Docket No. 52-001

SUBJECT: FINAL REPORT TO DOCUMENT THE DISPOSITION OF THE IIRG COMMENTS
ON THE GE NUCLEAR ENERGY (GE) ADVANCED BOILING WATER REACTOR
(ABWR) INSPECTIONS, TESTS, ANALYSES, AND ACCEPTANCE CRITERIA
(ITAAC)

INDEPENDENT REVIEW GROUP COMMENTS REQUIRING DISPOSITION BY GE

FIGURE 15E-1 ATWS MITIGATION LOGIC (ARI, FMCRD RUN-IN, RPT, RECIRCULATION RUNBACK)

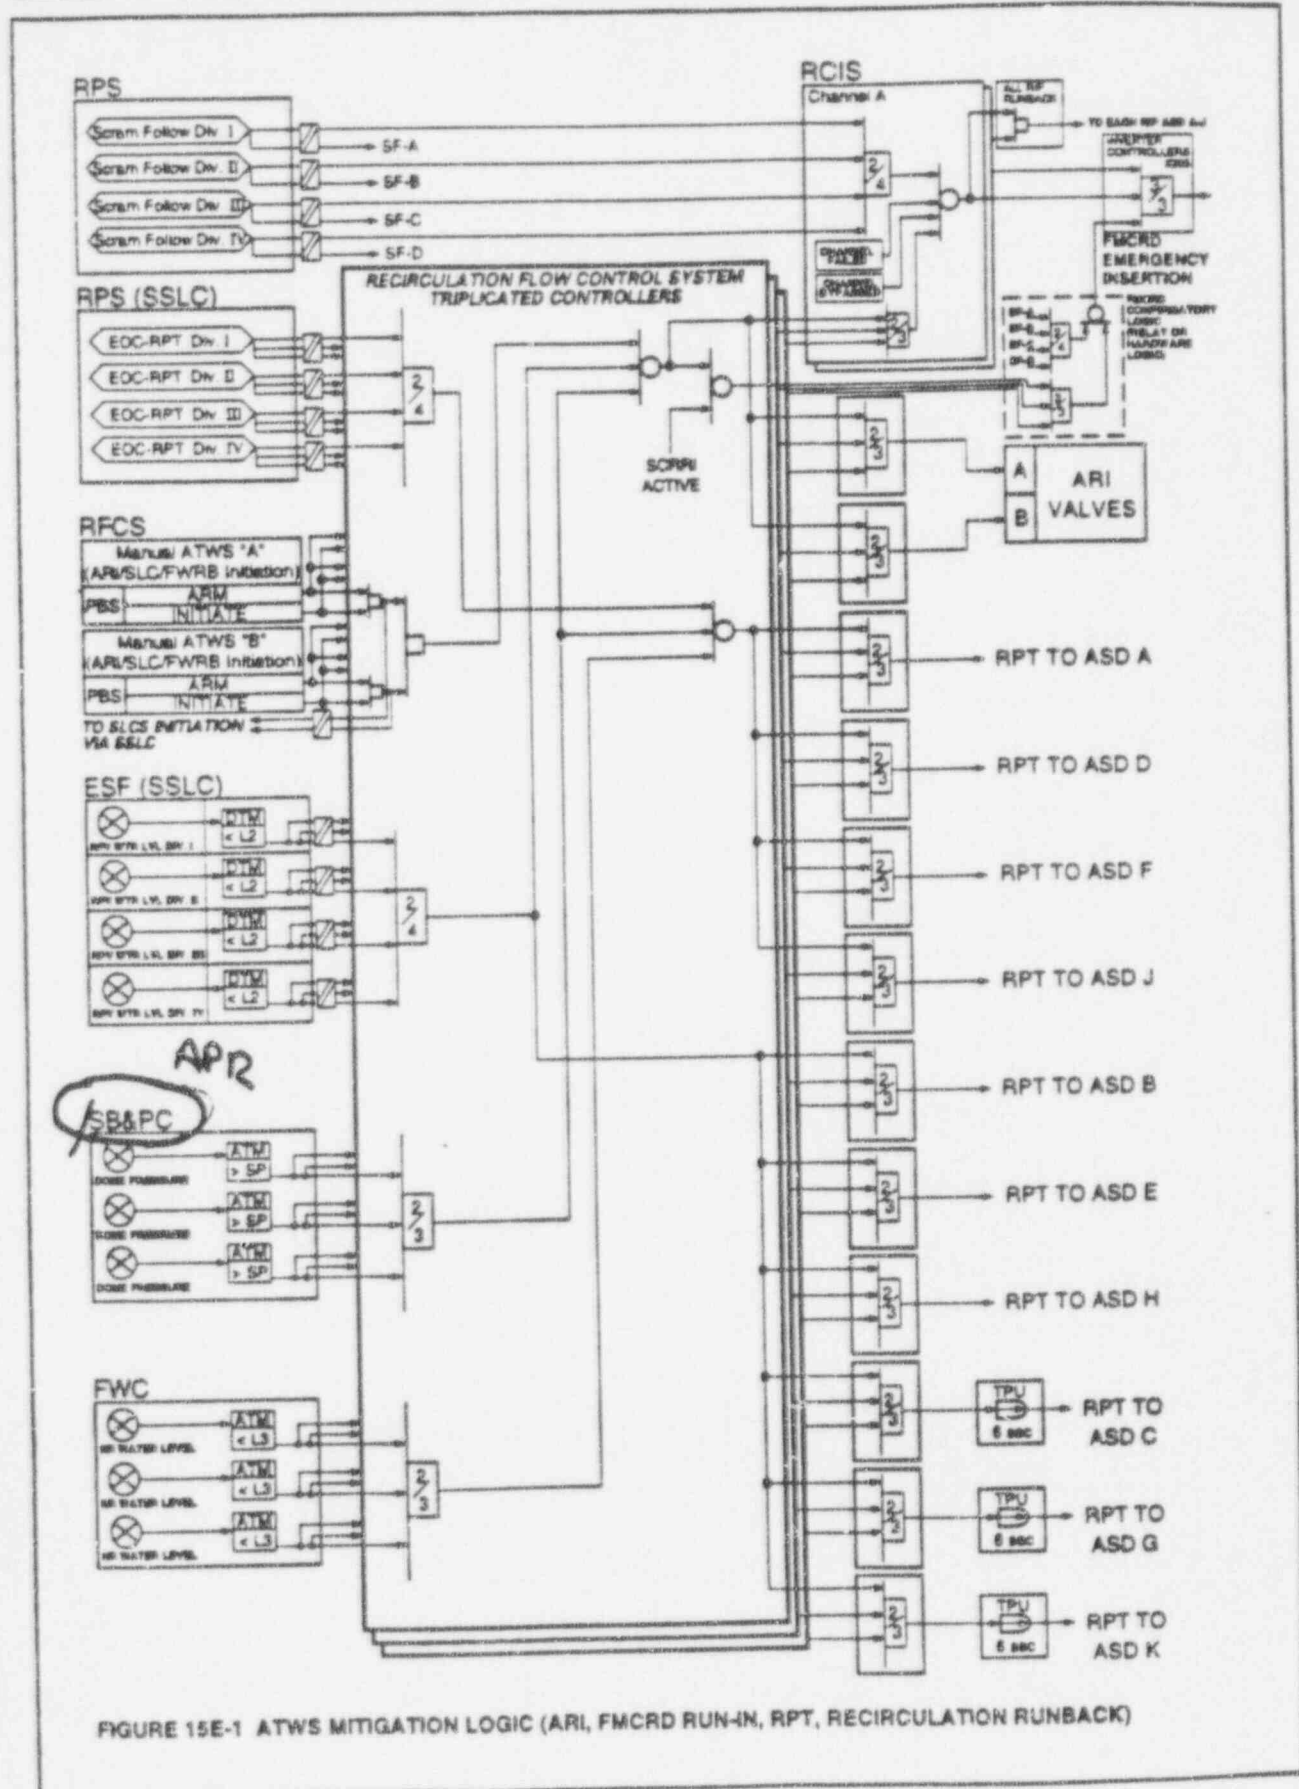
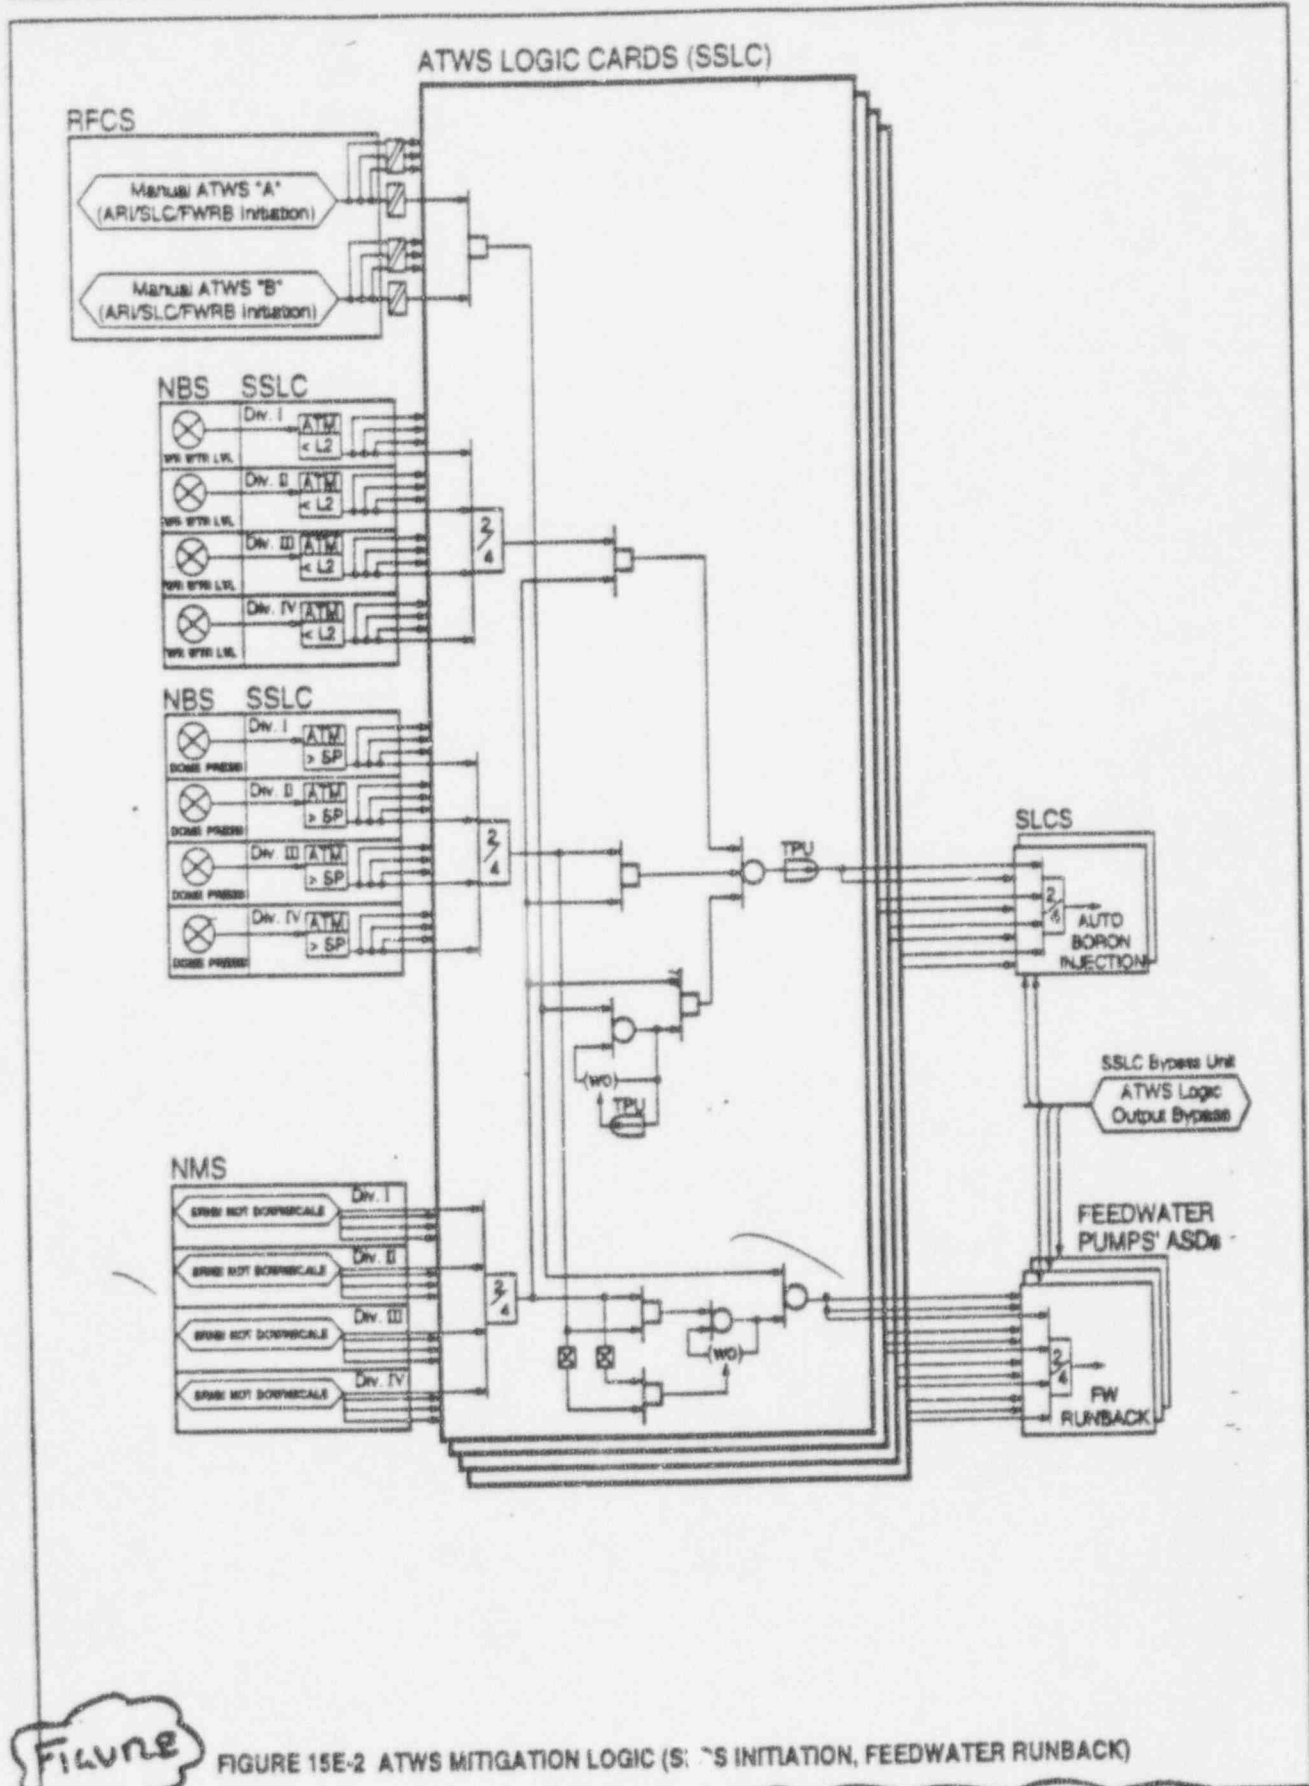
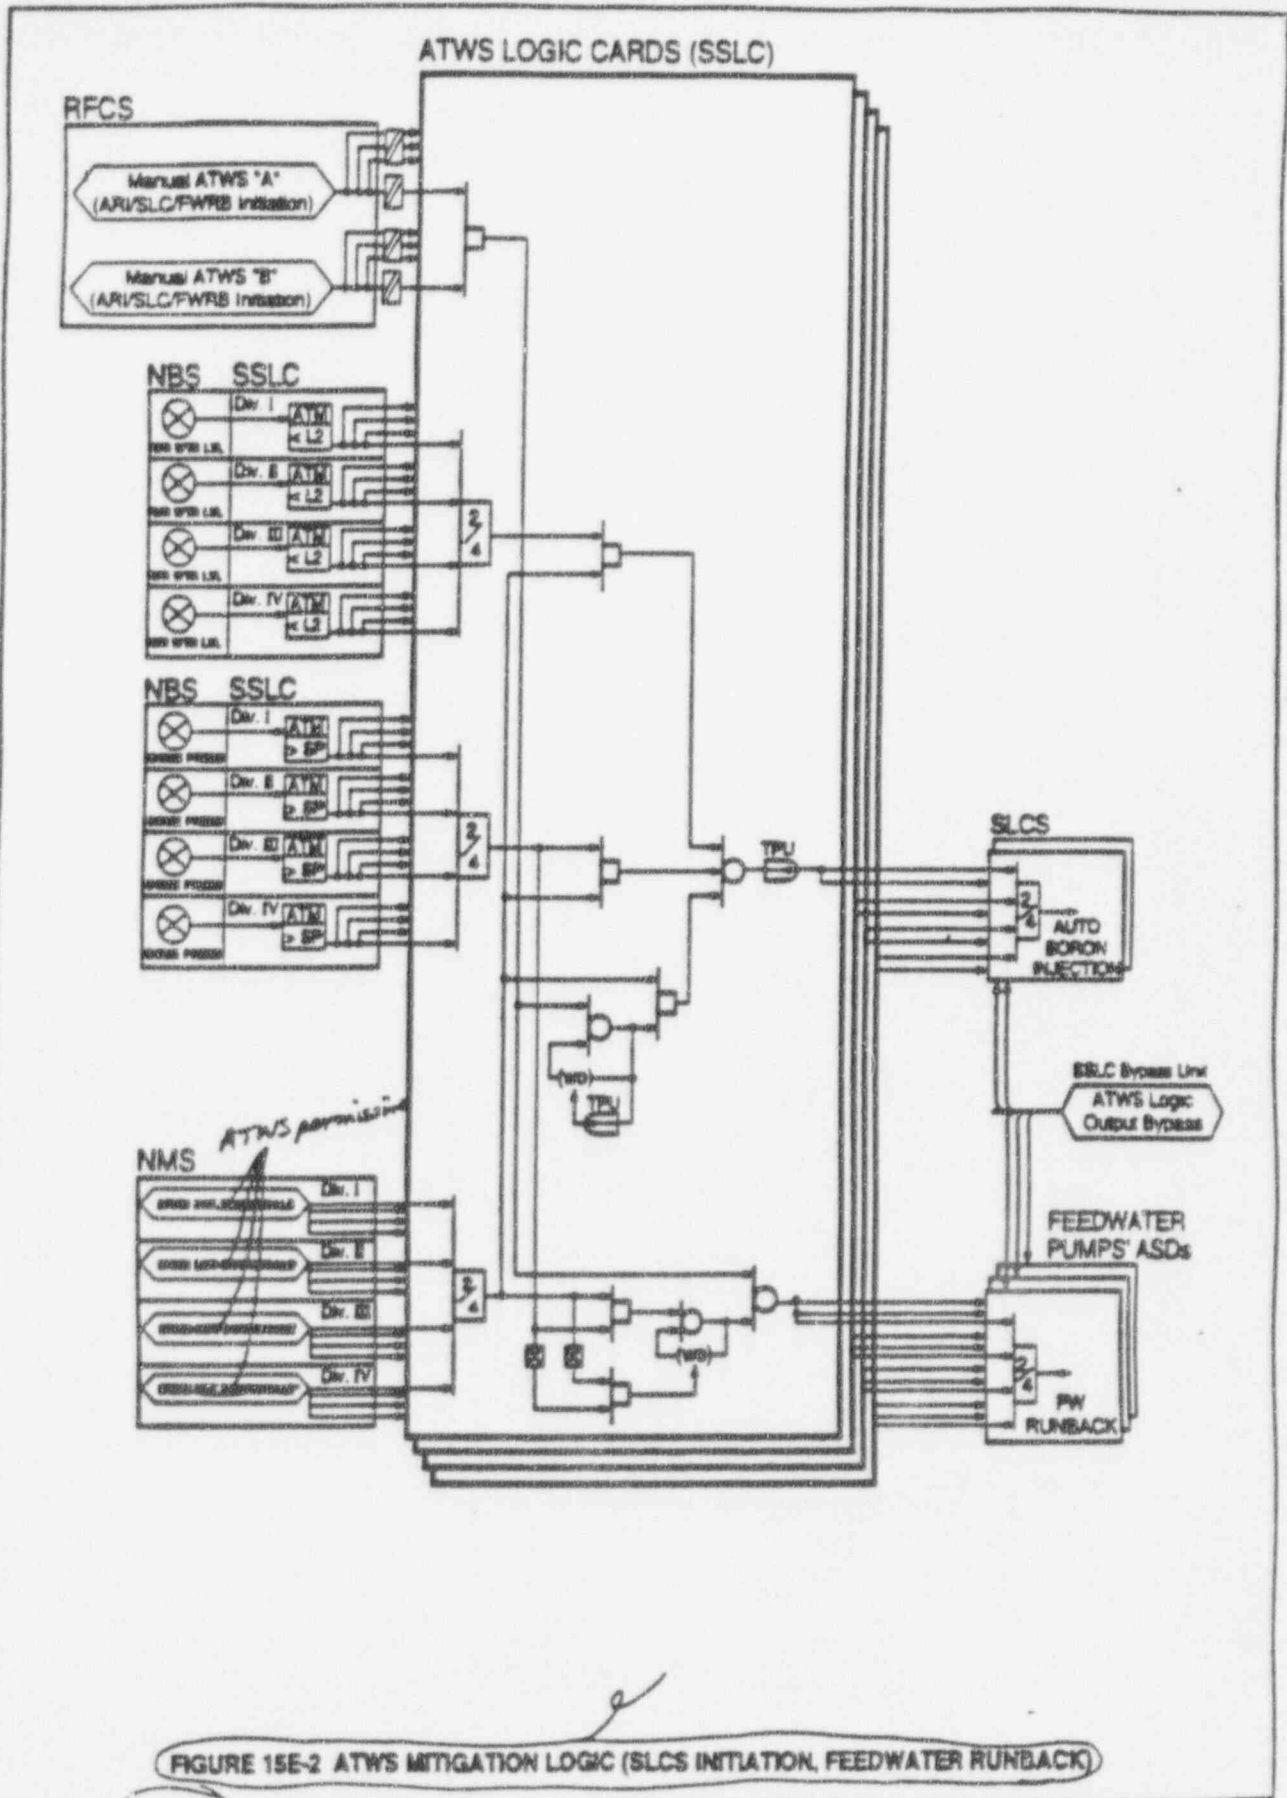
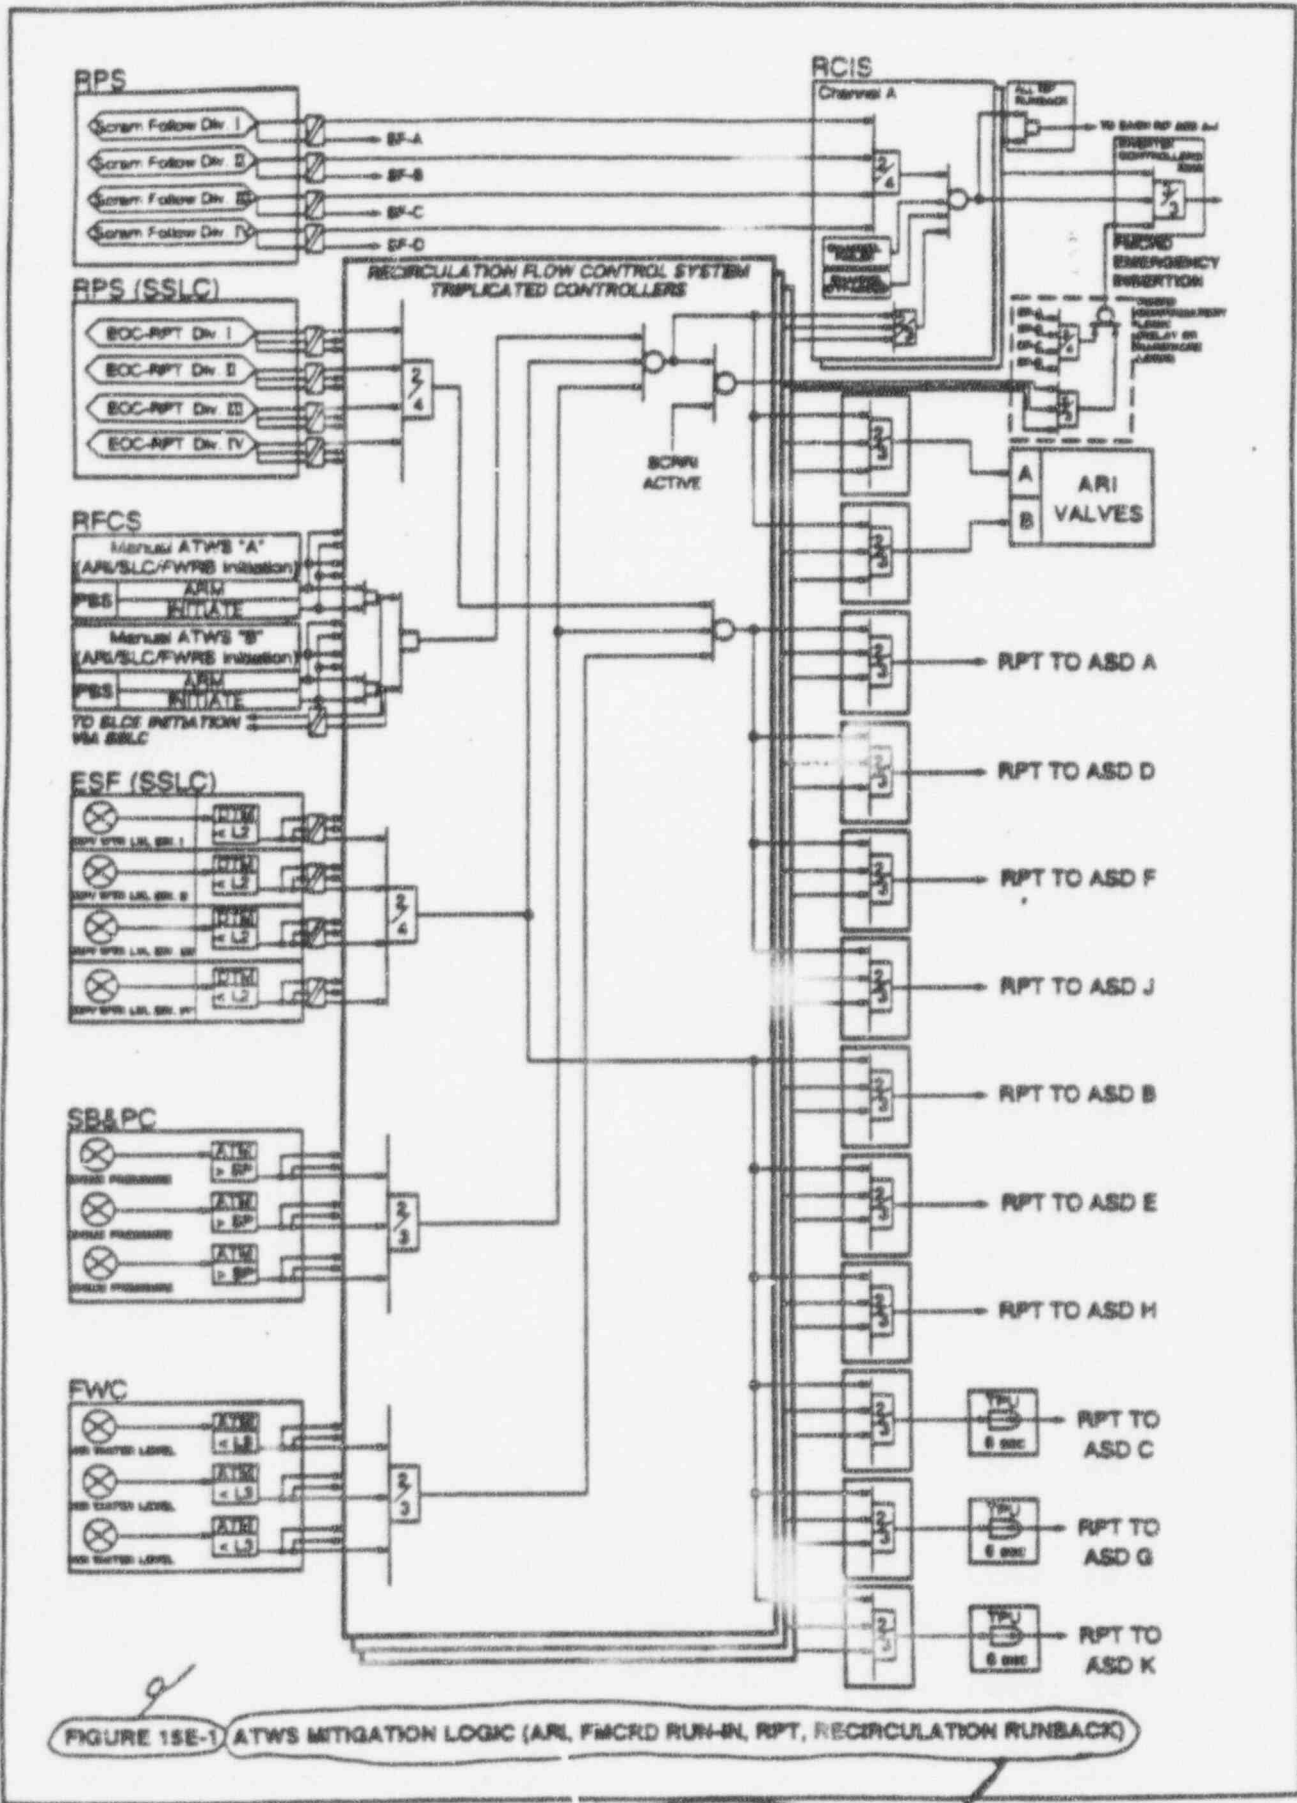
Figure 15E-1 ATWS mitigation logic indicates that the SB&PC system provides the steam dome pressure input to the RFC system. Per the system descriptions, the APR system is the RFC interface for the SB&PC system. See CDM 2.2.9 and 2.2.10 attached.

The title of figure 15E-2 is not consistent with the title of figure 15E-1. See SSAR, page 15E-18.

GE does not believe there are any inconsistencies requiring CDM changes. The SB&PC does in fact provide pressure signals to the RFC System for ATWS logic as shown on SSAR Figure 15E-1 and CDM Figures 2.2.8 and 2.2.10. The APR/RFC interface shown on Figure 2.2.9 is associated with the APR control function and is input to RFC for reactor power regulation (via flow control).
